New wheel stud for ECO Air COMPACT with disc brake (ET 120 mm)

With its new ECO Air COMPACT air suspension, BPW is also introducing a new wheel stud for the disc-braked ECO Disc TSB 3709 and TSB 4309 with ET 120 designs.

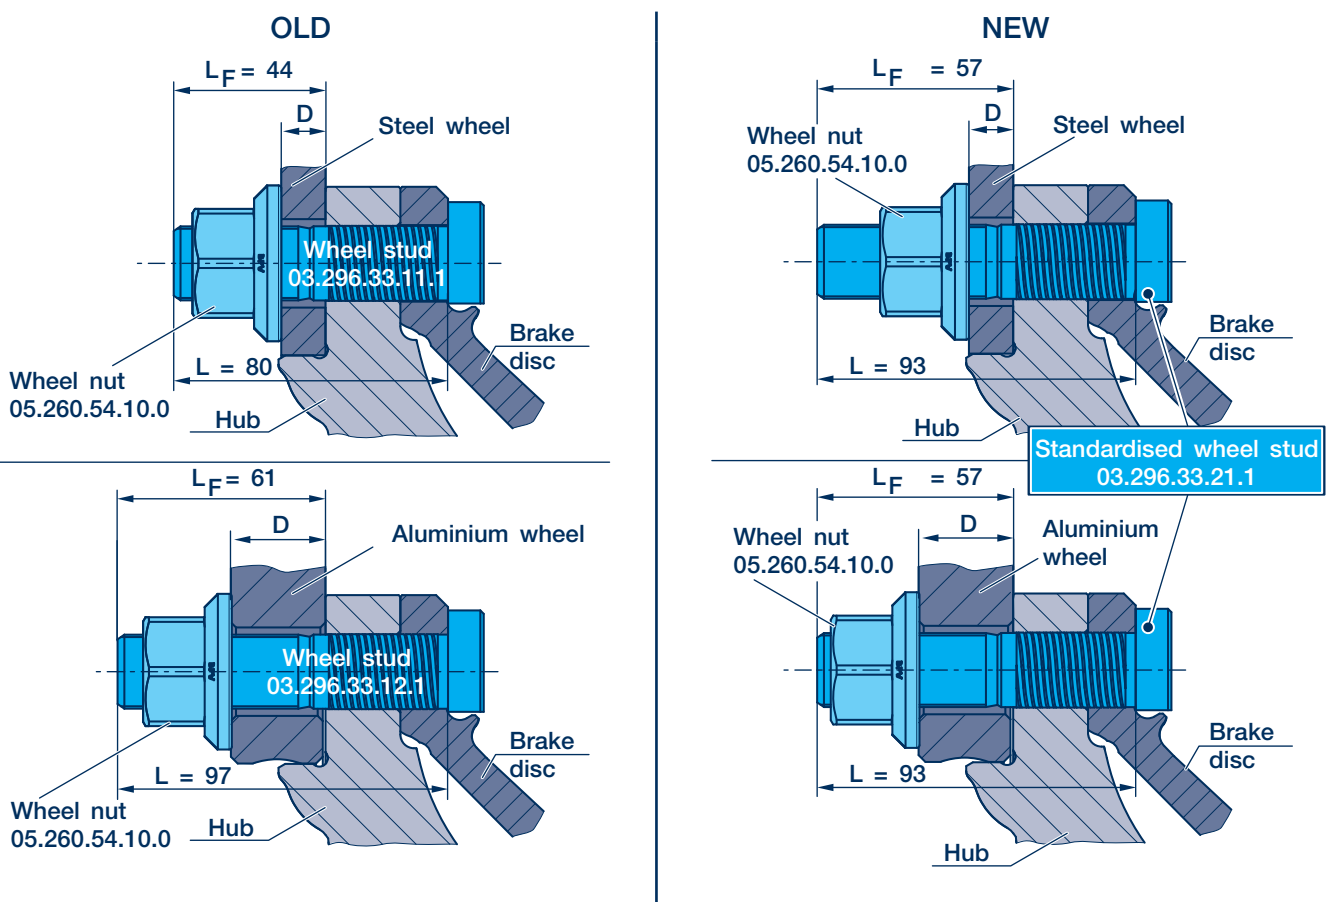
The new wheel stud has a length of 93 mm and can be used with all currently available forged aluminium wheels and steel wheels for single wheels. That means that it is approved for wheel discs with a wheel centre thickness of up to 28mm.

In the case of older wheels with a wheel centre thickness greater than 28 mm, BPW offers correspondingly longer wheel studs (03.296.33.12.1). For wheel with stud hole diameters of 32 mm, BPW supplies corresponding sleeve nuts (05.260.5.21.1).
